## COMPETITIVE ENGINEERING DEPARTMENT

RXL BULLETIN NO. 1 (1977/78)

### INFORMATION AND CHANGES RESULTING FROM ALASKA TEST TRIP AND RXL SEMINARS:

# RXL

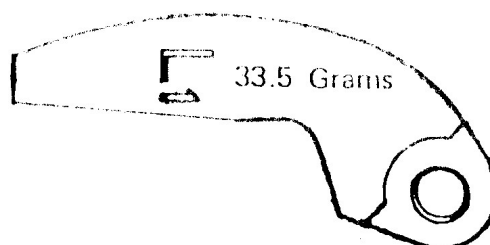
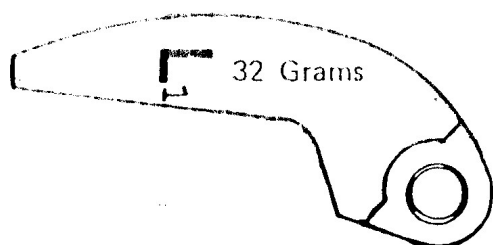
#### PROBLEM:

Low Engine RPM

High Engine RPM

Try next heavier blue clutch spring, part no. 7041080. If engine RPM needs to be raised more, install lighter clutch wts. 32 grams, part no. 5630188.

Try lighter orange clutch spring, part no. 7041060. If engine RPM needs to be lowered more, install next heavier clutch weight.

### TETHER SWITCH RELOCATION:

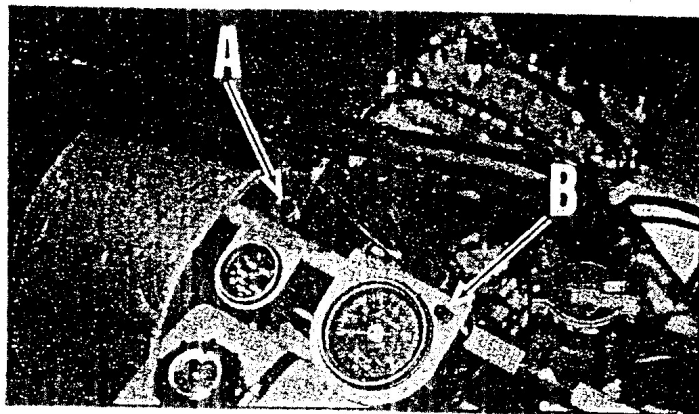
Refer to the photo below showing the relocation of the tether switch from the handlebar location (A) to the tachometer location (B). Measure 1/2" down from the inside radius of the tachometer mount and 1/2" in from the right side; see photo. At this point drill a 1/2" hole for the new tether location.

REAR CLOSE-OFF PANEL (INCLUDED IN RXL ENGINE KIT)

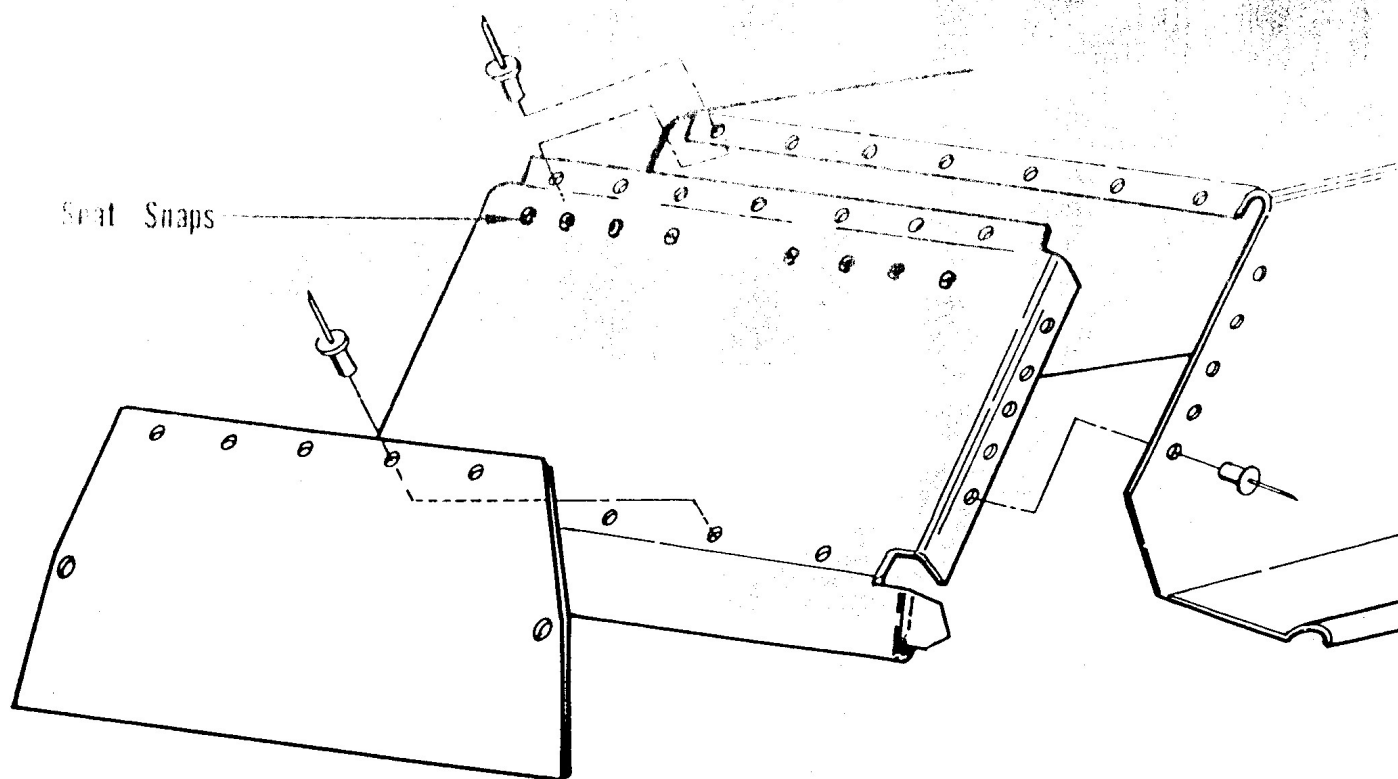
As a replacement part, Polaris has made available part number 5223877.

Procedure: Remove present close-off panel and snow flap by drilling out existing pop rivets. Install the replacement close-off panel using the top tunnel rivet holes as a line-up reference (see illustration). Secure with rivets on the top of the tunnel first. Next, drill the side panels with 5/32" drill size. Secure with 5/32 x 1/2" rivets. Fasten the snow flap to the close-off panel using 3/16 x 1/2" rivets. Relocate seat snaps and secure with rivets.
